My name is Crawford Munro, BSc CEng CWEM FICE FCIWEM, a Member of the Supervising Engineer's Panel under the Reservoirs Act since 1985 and I am a current member of Yorkley & District Angling Club.

PROVISION OF LONG TERM REPAIR AND ENHANCEMENT WORK ON LOWER CANNOP POND DAM

2nd March 2023

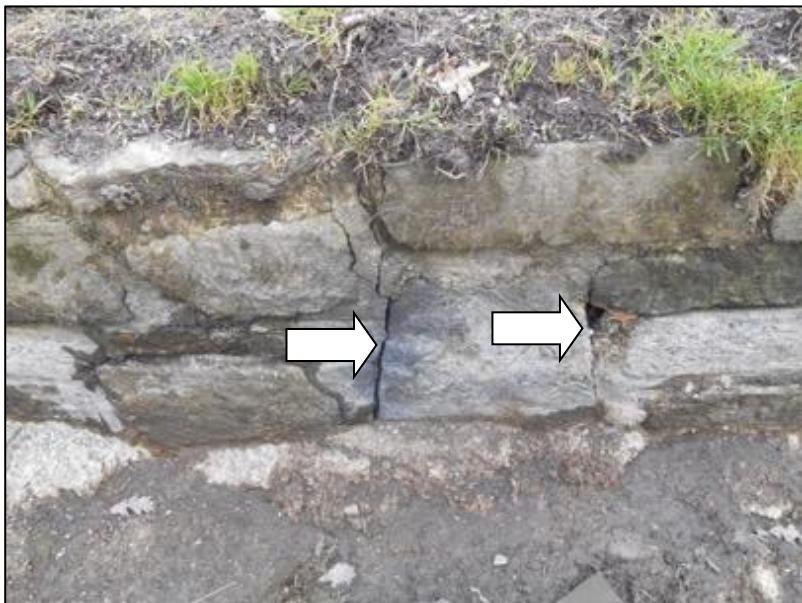
My comments are limited to Lower Cannop Pond dam meantime. A recent satellite image of the dam is shown below. There is good access to the site from the west off New Road. The Forest of Dean Stone Firms Limited's facility extends from the west to about the mid-length of the dam. The section of dam in this area is now massive and I am not aware of any seepage or settlement issues on this part of the dam embankment. Moving eastward, the dam crest is also substantial but to a lesser extent and about 10m wide

APPENDIX 1

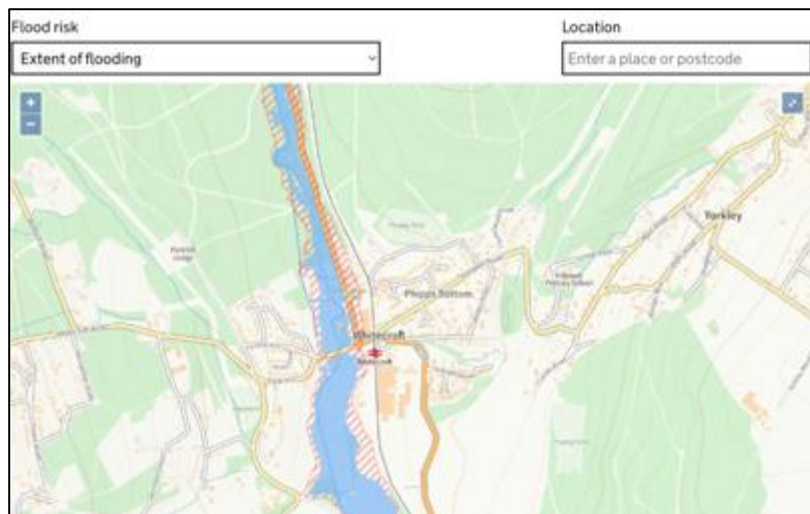
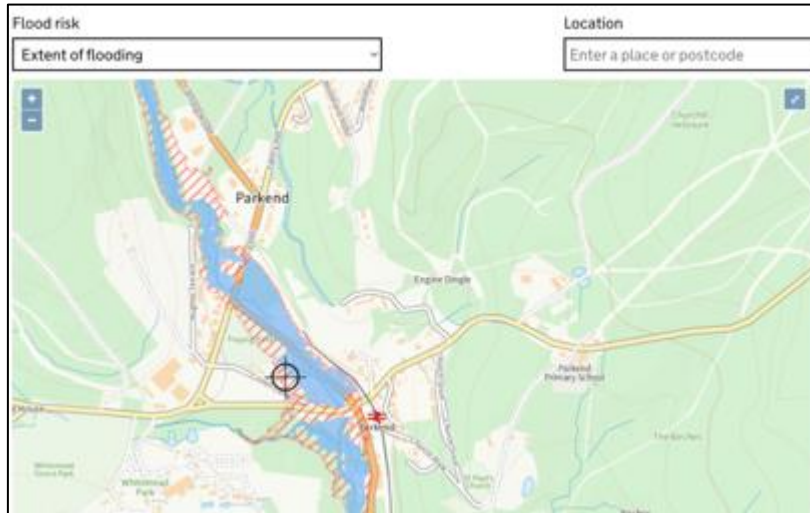
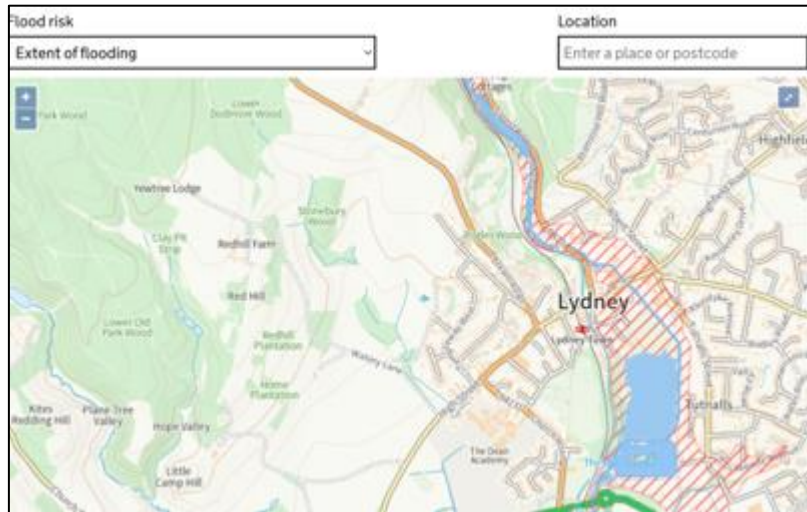
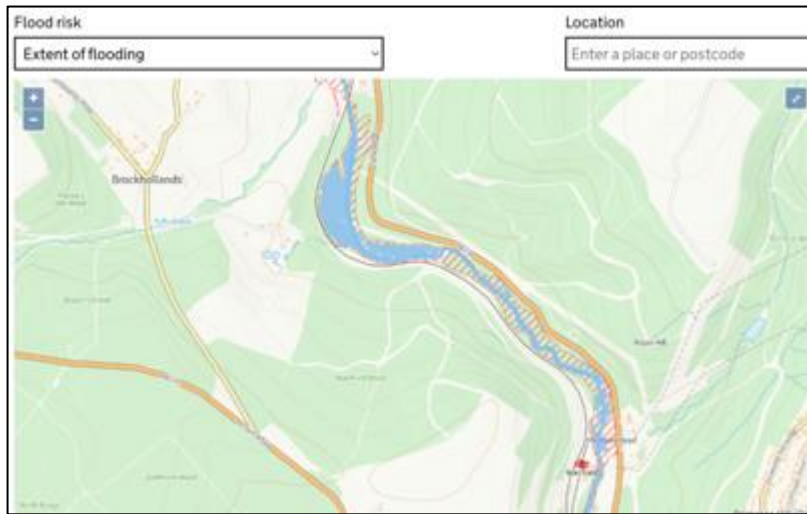
Some examples of flooded areas during dry days and wet days from a breach of the lower dam are shown in Appendix 1.

(blue shading signifies extent of flooding when river levels are normal and red hatching when there is also flooding from rivers.
